**ADDENDUM #1- Issued 9/3/14**

CITY OF TORRANCE  
3031 Torrance Blvd.  
Torrance, CA 90503

**Bid for McMaster Park Building and Park Improvements**

ADDENDUM # 1

RFI

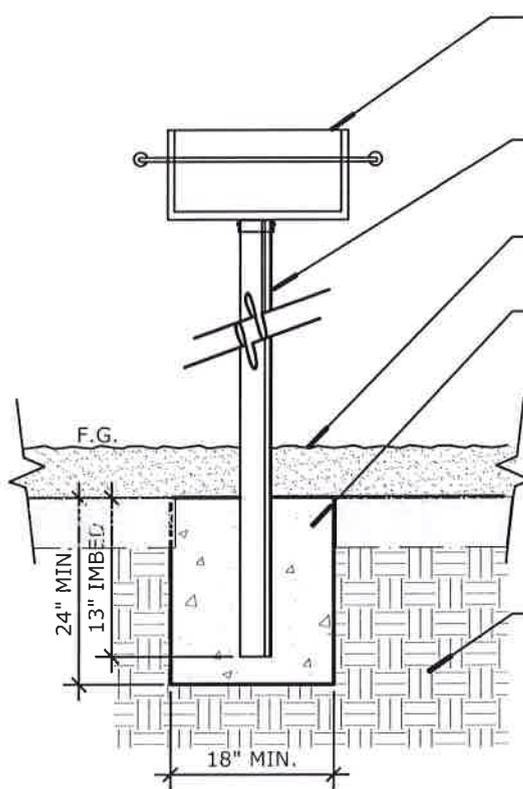
4. Sheet L-202/b calls out to see the structural engineer's details for the footing for the Courtyard TS Gate. After looking through the structural sheets, we haven't been able to identify a detail for the footing. Please provide detail.

Description: See dimensions for concrete footing provided hereon

- METAL PEDESTAL BARBEQUE - REFER TO CONSTRUCTION INFO. PLANS FOR MODEL, MANUFACTURER, AND COLOR INFO.
- ROUND STEEL POST TO RECEIVE ONE COAT OF PRIMER, AND TWO COATS OF NON-TOXIC, RUST RESISTANT PAINT.
- DECOMPOSED GRANITE. SEE DETAIL.
- CONCRETE FOOTING - SIZE AND REINFORCEMENT PER MANUFACTURER'S RECOMMENDATIONS
- PRESATURATE AND COMPACT SUBGRADE PER GEOTECH. SOILS ENG.'S RECOMMENDATIONS.

NOTE: BARBEQUE TO BE ORDERED BY CONTRACTOR. CONTRACTOR TO ASSEMBLE AND SECURE BARBEQUE TO CONCRETE PER MANUFACTURER'S RECOMMENDATIONS. CONTRACTOR SHALL VERIFY BOLT LOCATIONS DIMENSIONS WITH ACTUAL BARBEQUE ON-SITE PRIOR TO INSTALLATION.

L-2

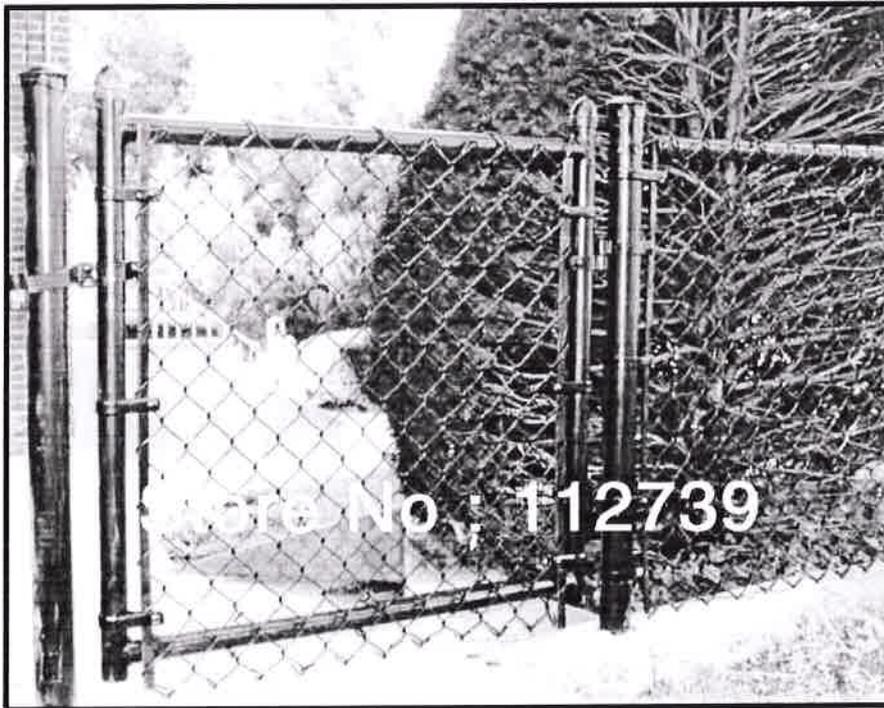
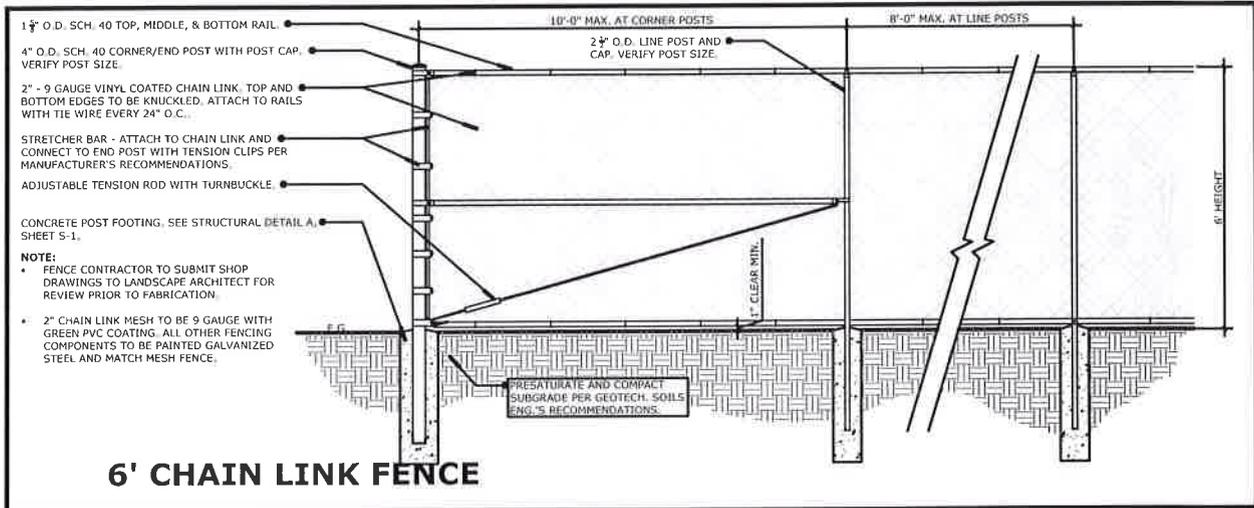
1. Please provide the models for the Dumar BBQ's

Description: Provide Dumor spec for BBQ: Grill 21-00

**42" CHAIN LINK FENCE AND GATE**

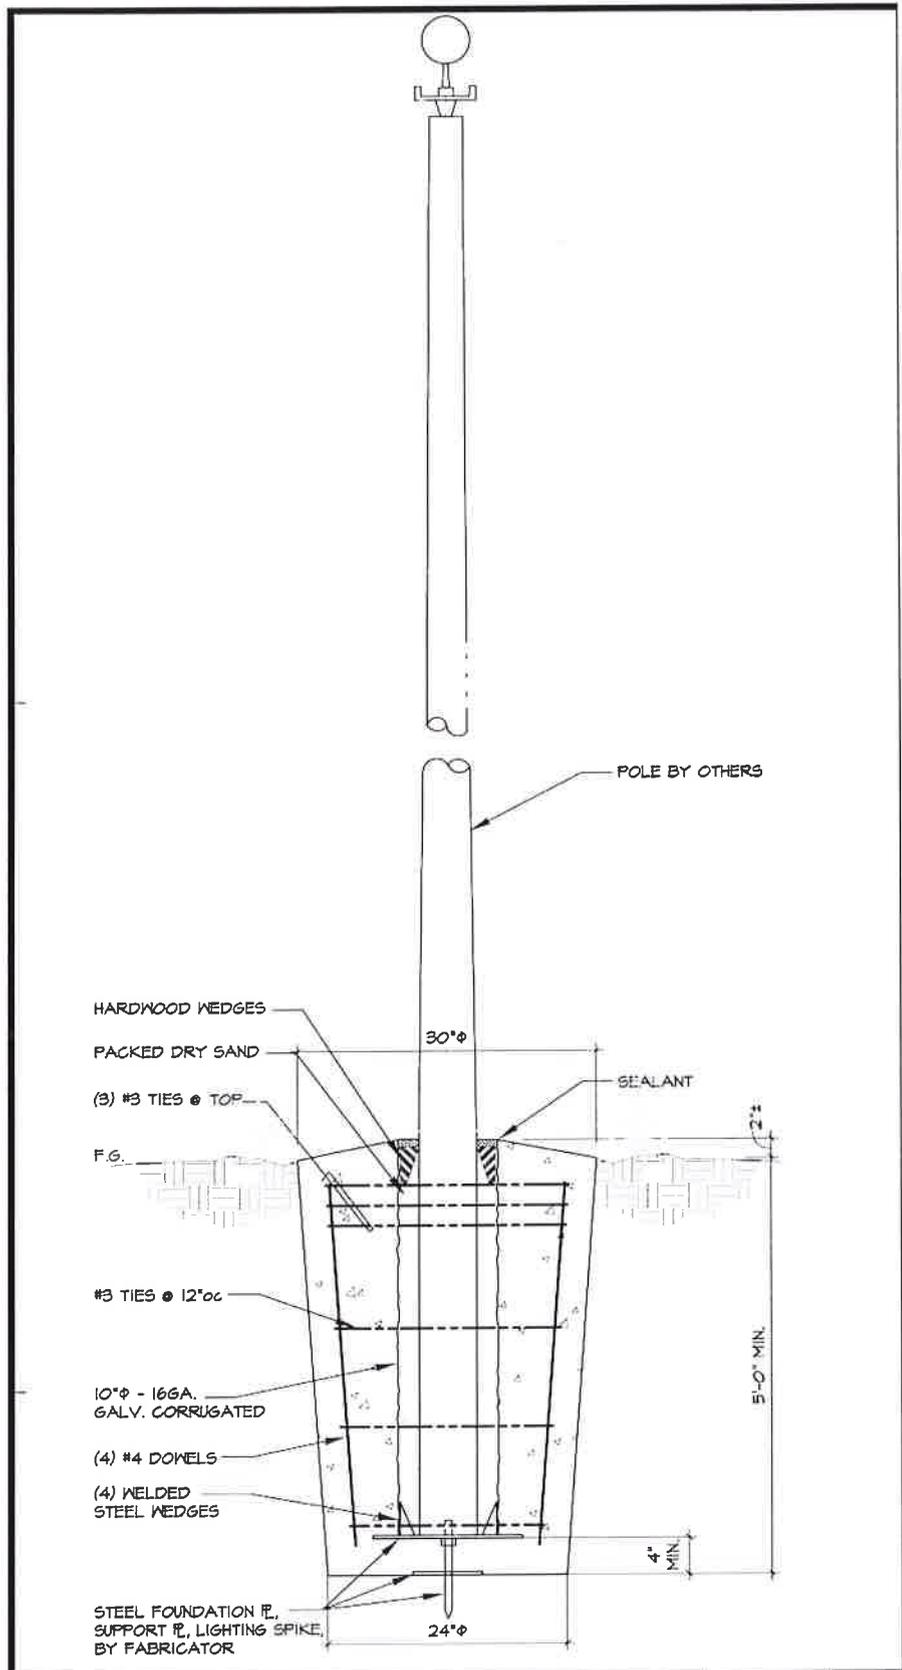
2. Sheet L-105 calls-out detail N/L-201 for a 12" wide concrete band. Does the chain-link fence sit atop this concrete band? Are the limits of the concrete band the same as the chain-link fence?

5. Please provide spec for chain link fencing.

Description: Provide spec for chain link fencing; Industry standard fencing as shown above. PVC coated, color: Green. All other components to be painted to match PVC coating.
